**HEARINGS EXAMINER MEETING AGENDA**  
**Thursday, February 6, 2020, 5:00 PM**  
**City Hall, 616 NE 4th Avenue**

- A. Public Hearing for Vutukuri Duplex (CUP19-02)  
Presenter: Madeline Sutherland, Assistant Planner

**STAFF REPORT**

Vutukuri Duplex  
File No. CUP19-02  
(Related files: DR19-08)

# SITEPLAN

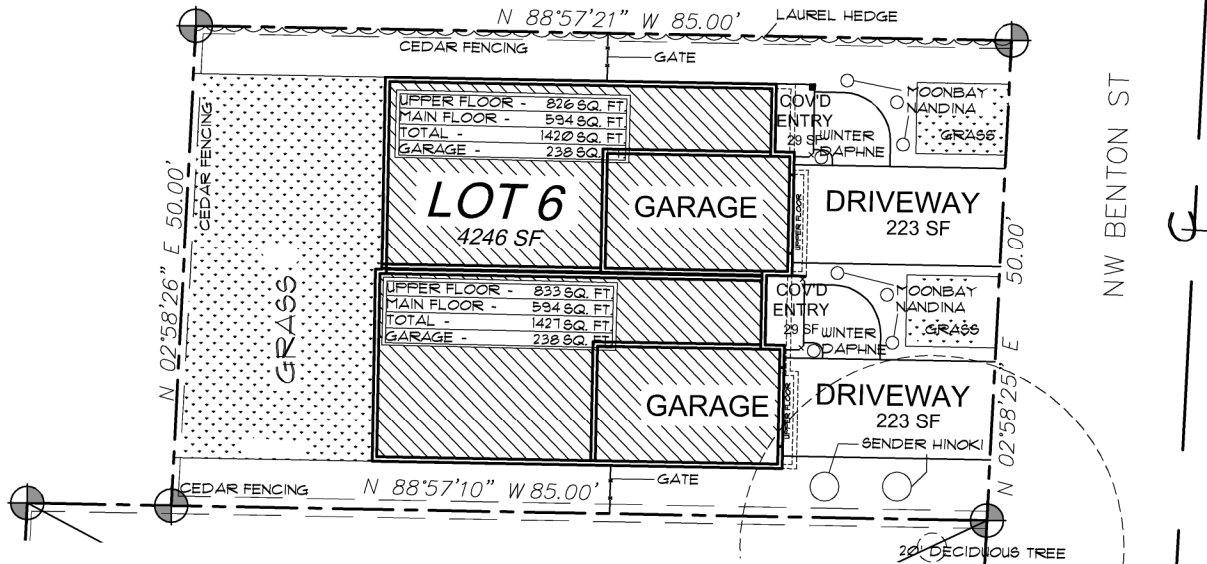
Building setbacks are based on lot sizes per CMC 18.09.040 Table 2. The lot size is approximately 4,594 square feet. The setback standards for a lot that is under 5,000 sq. ft. are as follows: Front yard is 20-feet; Side yard is 5-feet; Rear yard is 20-feet. The applicant’s proposed site plan demonstrates compliance with these setback requirements.

Residential uses must provide adequate off-street parking pursuant to CMC Chapter 18.11.130 *Standards*. A “duplex” use requires two off-street parking spaces per unit. The site plan shows that each garage includes one parking space, and a second space in each driveway, and therefore meets this requirement.

The subject property is located in a residential neighborhood with a mix of designs and densities to include several multi-family residences. The design of the building is influenced by the existing character of the neighborhood to include architectural features and materials consistent with that of a residential use. The design of the building is discussed in further detail below. Per CMC 18.09.040 Table 1, the maximum lot coverage is 40%. The applicant is proposing 43.4% lot coverage.

**FINDING:** The development design is generally compatible with the surrounding land uses. The lot coverage of 40% will need to be met and a condition is warranted.

8. The maximum lot coverage is 40% shall be met.
9. Prior to engineering plan approval, a final landscape plan consistent with the landscaping standards in CMC 18.13.050 and the Camas Design Manual planting specifications shall be submitted to the city for review and approval.

# LANDSCAPE PLAN

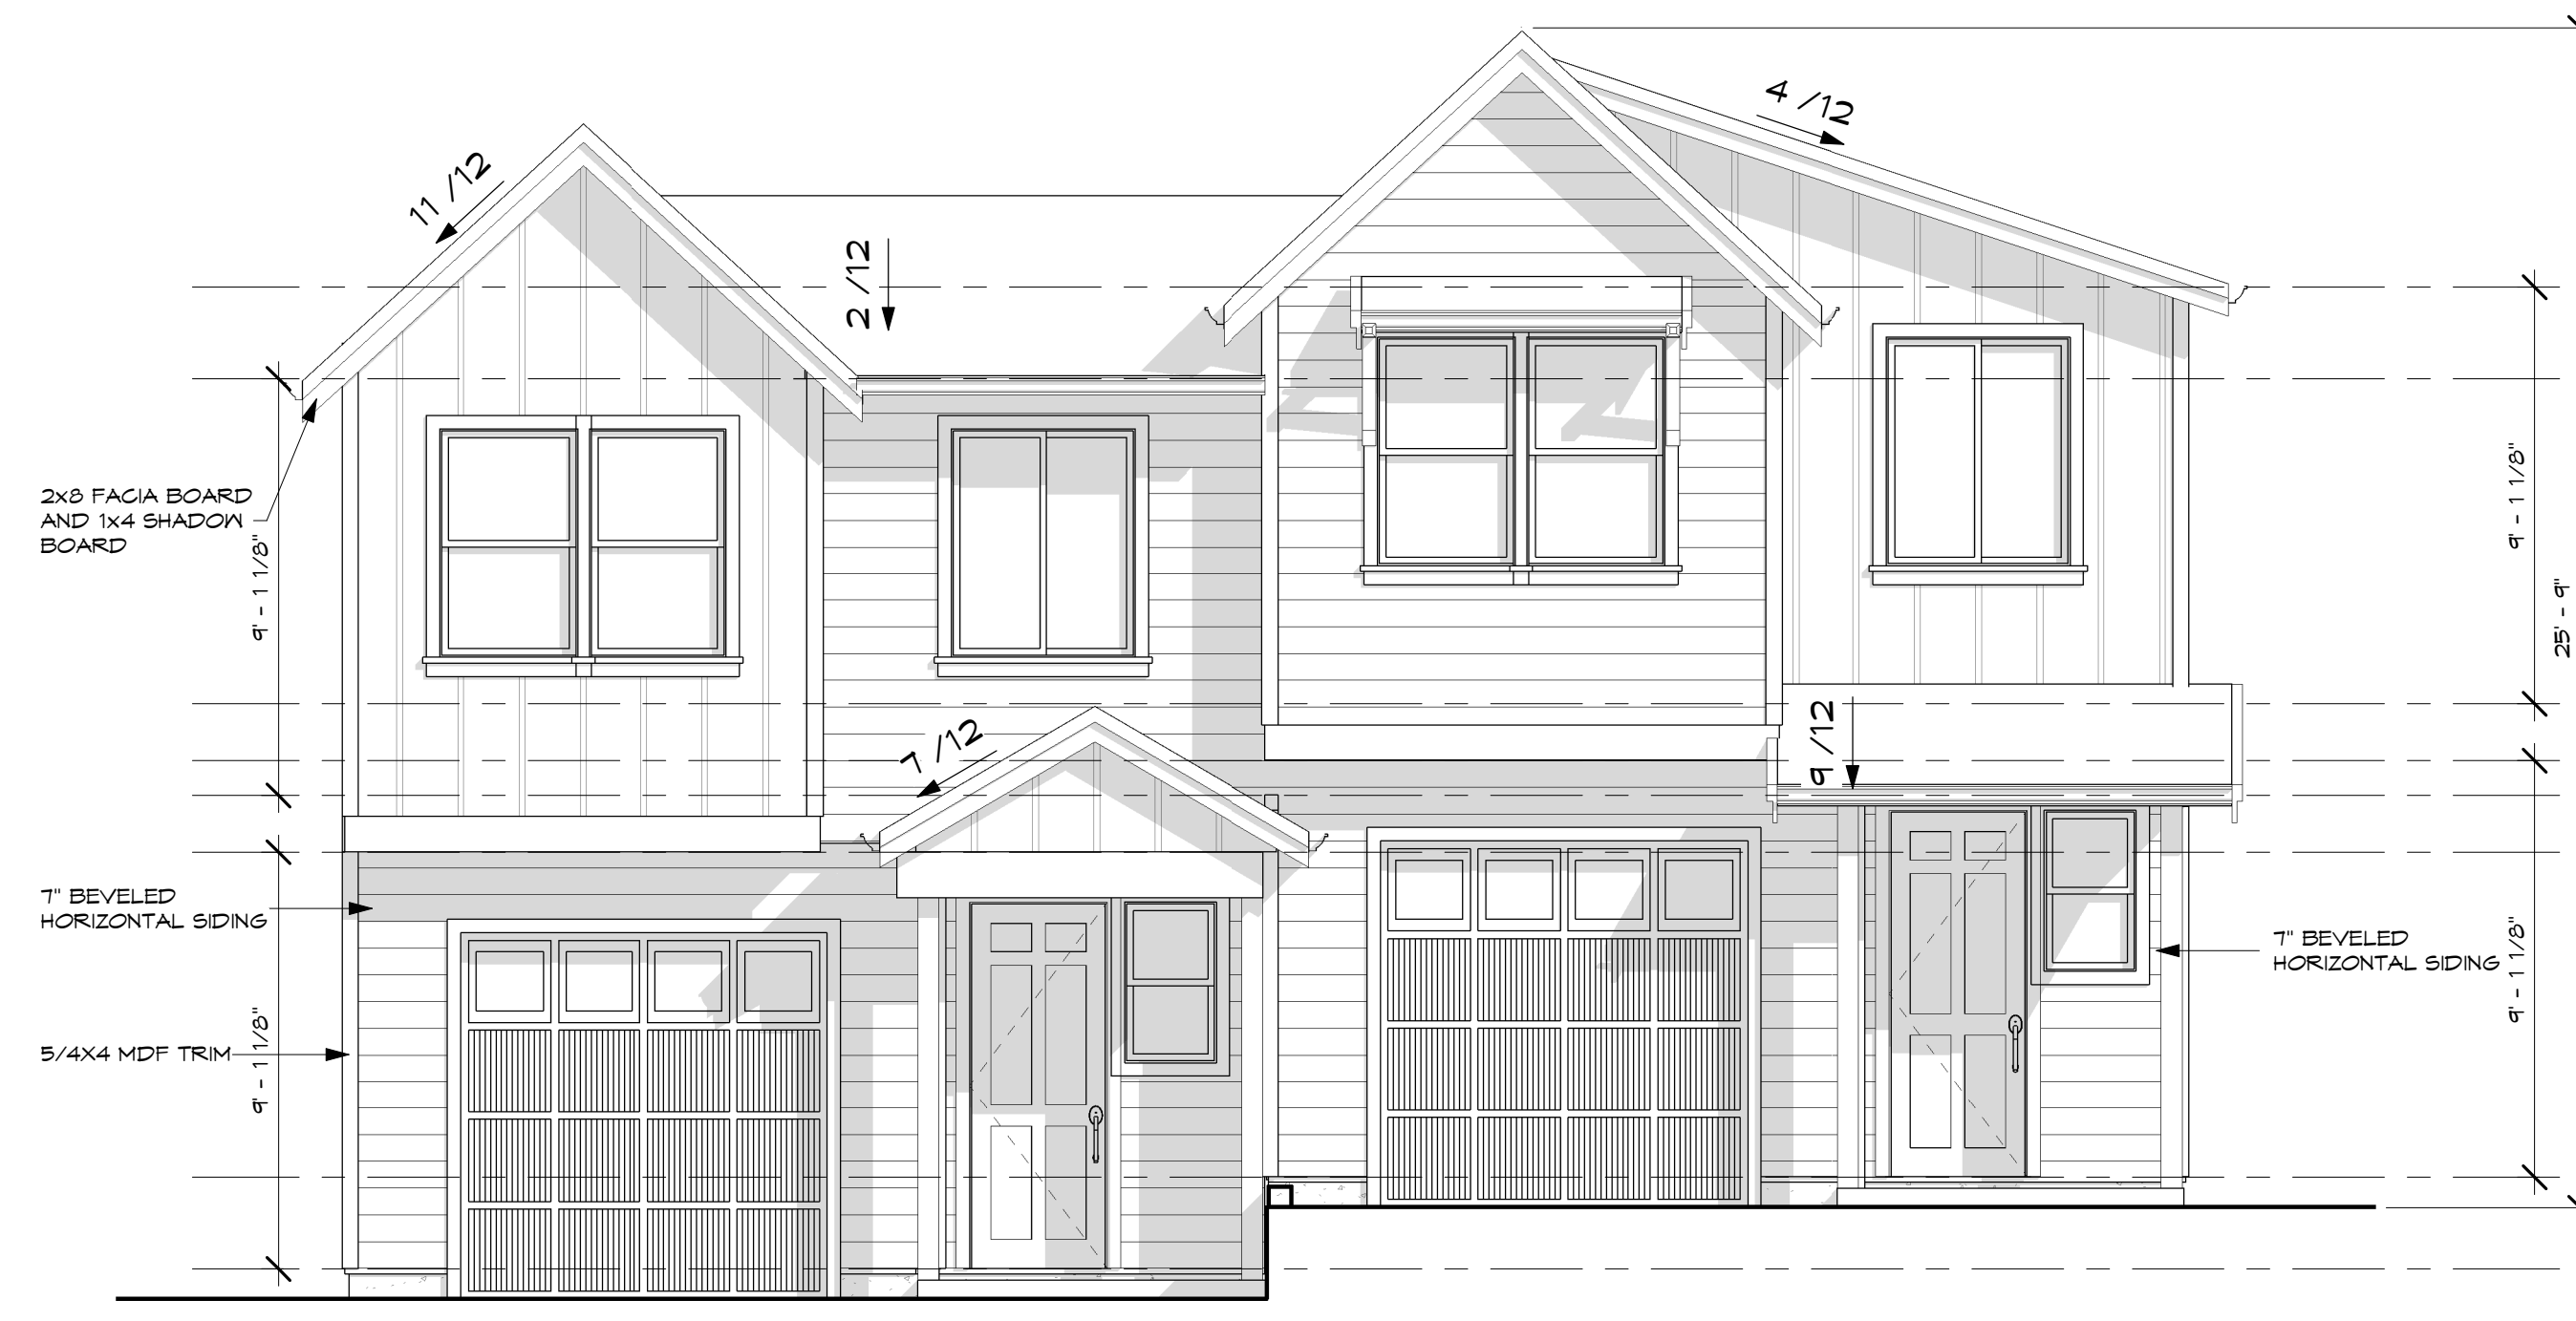
Per the landscape plan, the applicant is proposing two trees in the front yard of the duplex in compliance with CMC 17.19.030.F.1 which states, “*Each dwelling unit within a new development shall be landscaped with at least one tree in the planting strip of the right-of-way, or similar location in the front yard of each dwelling unit, with the exception of flag lots and lots accessed by tracts. Required trees shall be a minimum two-inch diameter at breast height (dbh) to create a uniform streetscape (dbh is four and one-half above the ground as measured from upside of tree)*”. The existing planter strip is not wide enough to sustain street trees, therefore street trees will be required in the front yard of the duplex. A duplex consists on two dwelling units, therefor two street trees will be required. Per the applicant’s landscape plan, this criteria is met.

**FINDING:** Staff finds the two trees proposed in the front yard meet the street tree requirements. The property owner is responsible for replacing the trees if they fail to survive, therefore appropriate measures shall be taken to ensure the trees survival. If a tree is removed or dies, it must be replaced within one year. A final landscape plan shall be submitted to the City prior to engineering plan approval. A condition will be warranted.

There are no significant trees on site. Per CMC significant trees include “*evergreen trees eight inches DBH, and deciduous trees twelve inches DBH*” and “*does not include hazard trees or invasive species*”. The applicant is required to provide 20 tree units per acre per CMC 18.13.051. The property is .11 acres and as such, 2 tree units are required. Tree plantings are required to be a minimum of 2” cal. Which calculates to two trees per CMC 18.13.051 Table 2. The two Sender Hinoki trees per the applicant’s landscape plan meet this requirement.

A final landscape plan consistent with the landscaping standards in CMC Chapter 18.13 and the Camas Design Manual planting specifications and landscape notes should be submitted to the City for review and approval prior to engineering plan approval. Trees should be installed prior to final occupancy and conditioned as such.

**Front Elevation**  
1/4" = 1'-0"

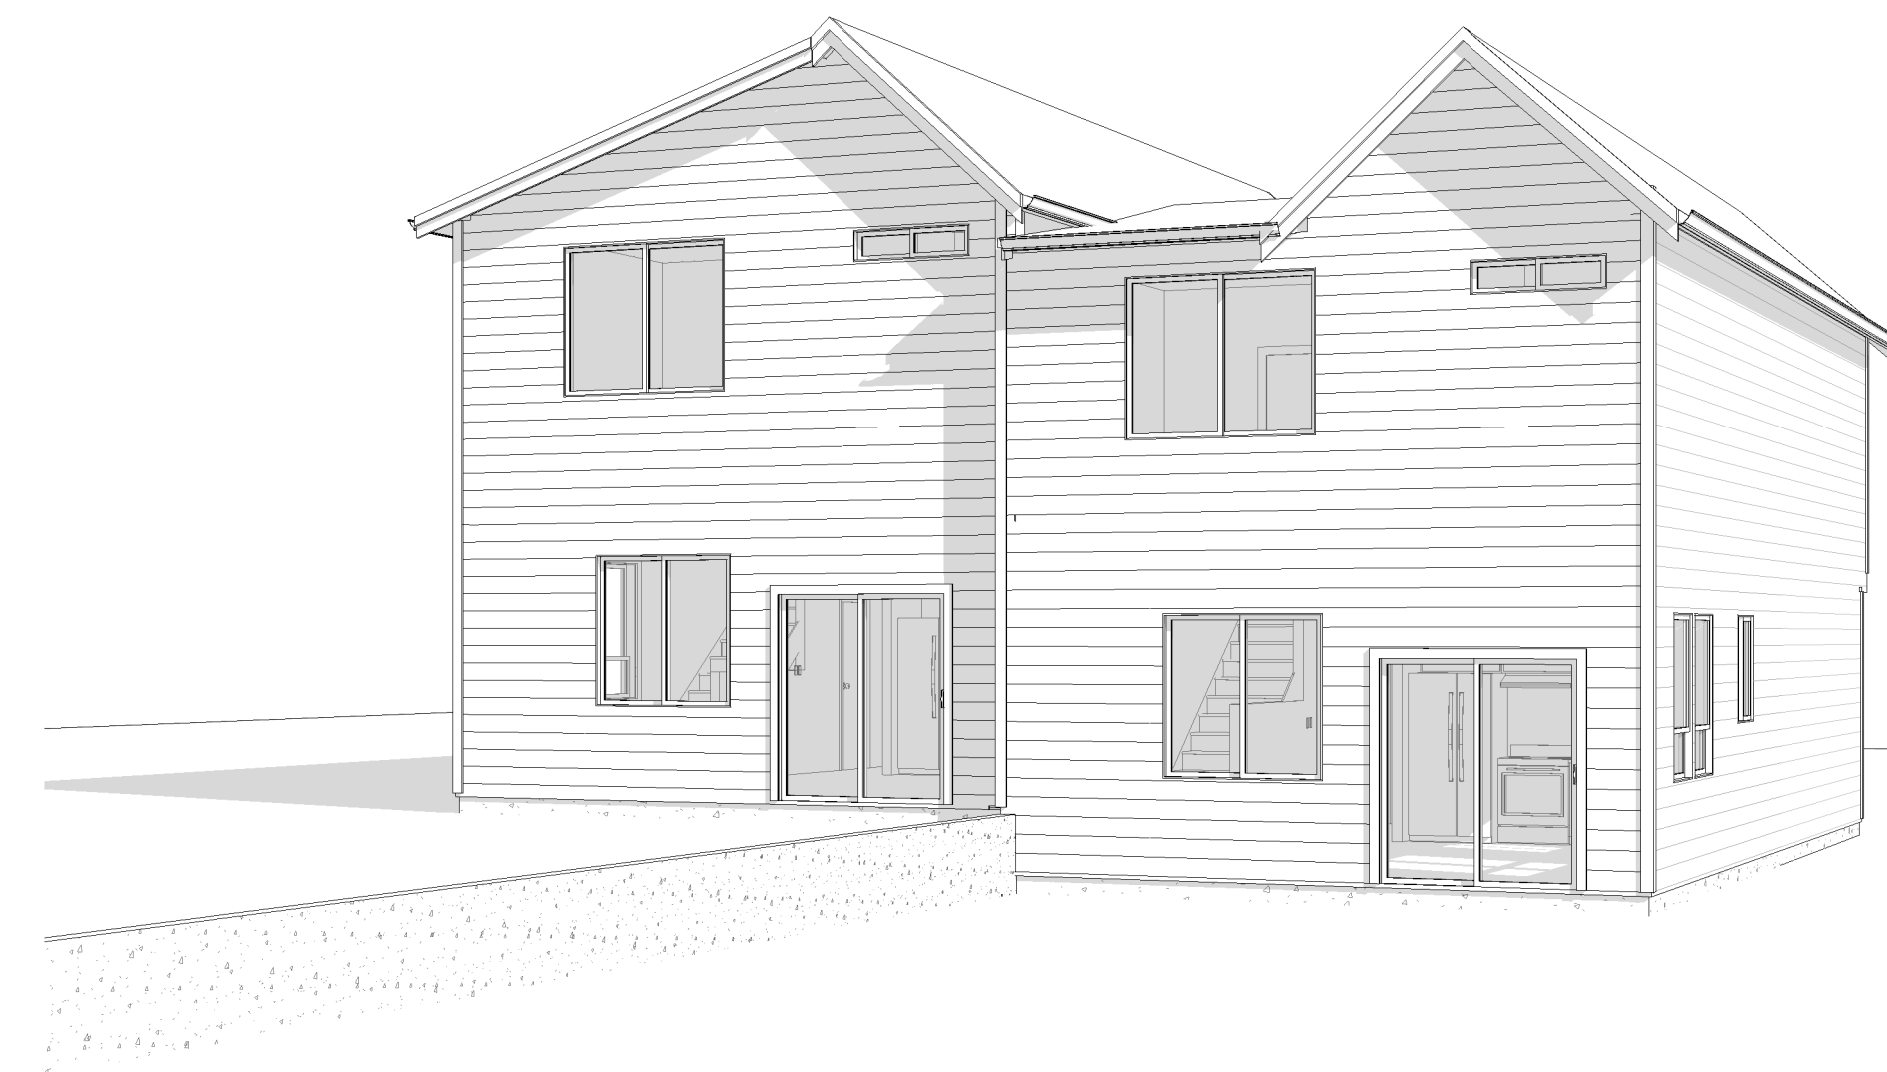
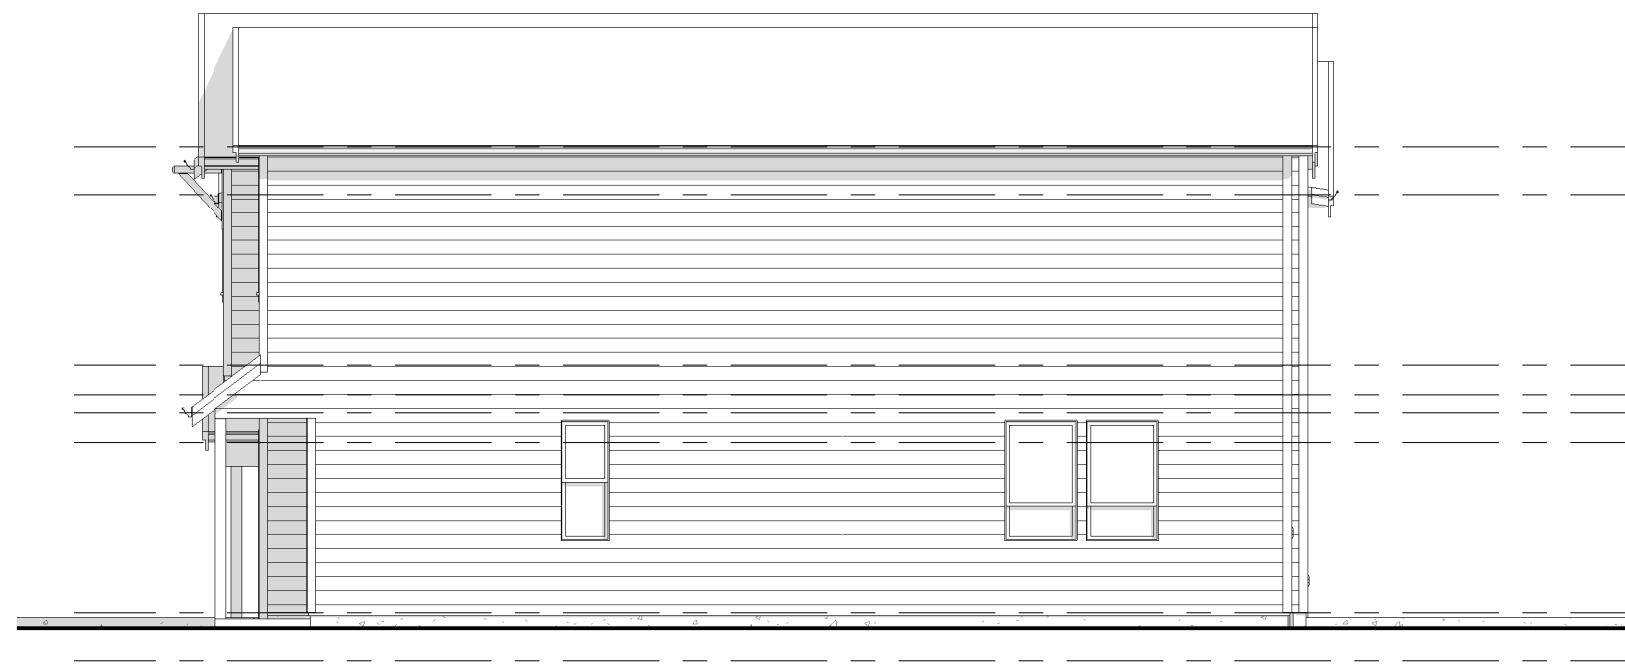
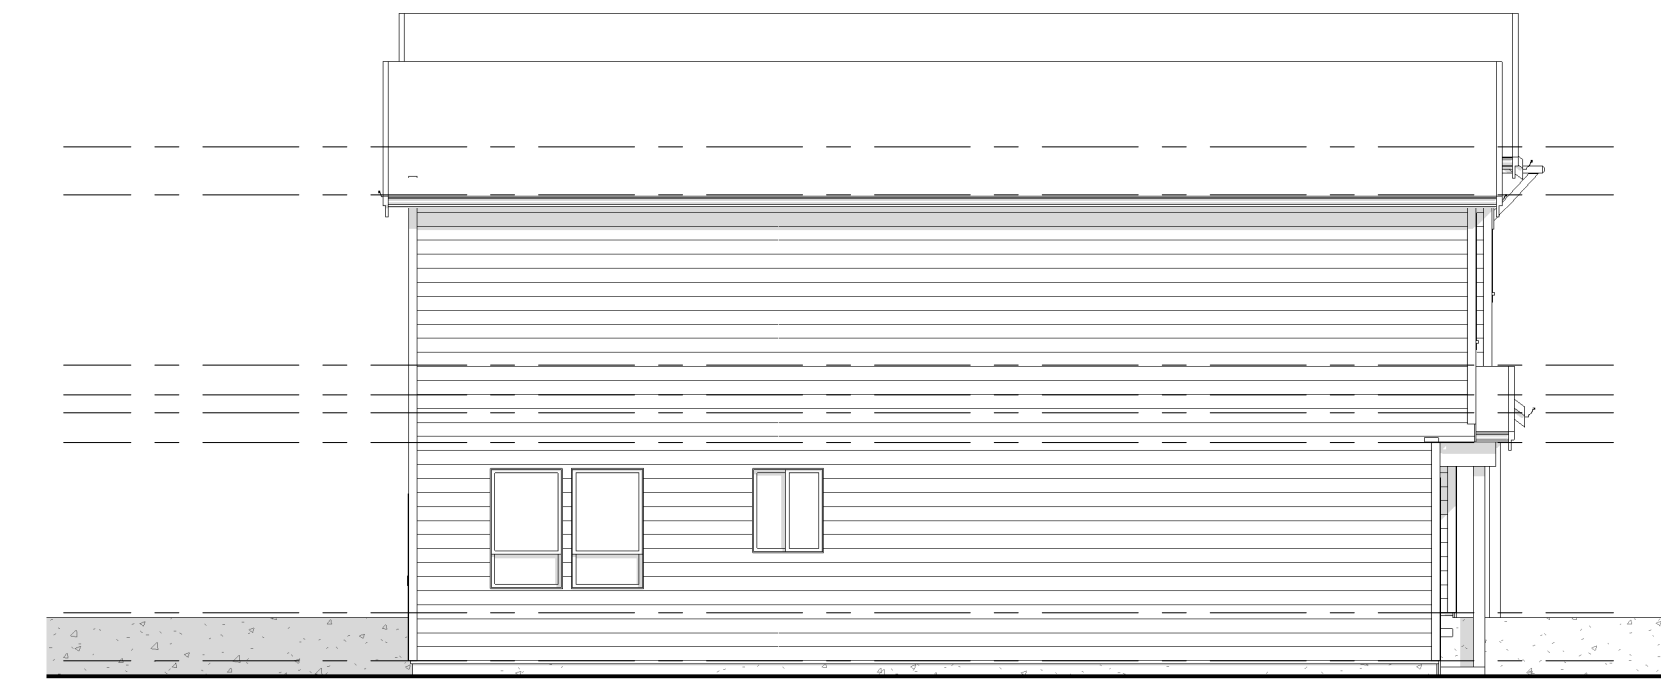
The craftsman style duplex building is made up many materials consisting of Hardie products such as lap, board and bat, barge and trim. The proposed colors are earth tones. Materials and colors selected are consistent with those seen on nearby residential structures. Any landscape, parking lot or building lighting should be directed, hooded or shielded away from surrounding properties, a condition is warranted.

The Committee recommended the Applicant add an architectural feature on the rear exterior wall above the door. The design review manual does not administer design review principles to the rear of buildings unless there is a street directly behind the building. A lot with a single family residence is behind the subject property therefore the design review committees recommendation will not be a condition by staff. The garages account for less than 50% of the front façade. The committee overall agreed with the duplex produced a complementary façade that faced the street.
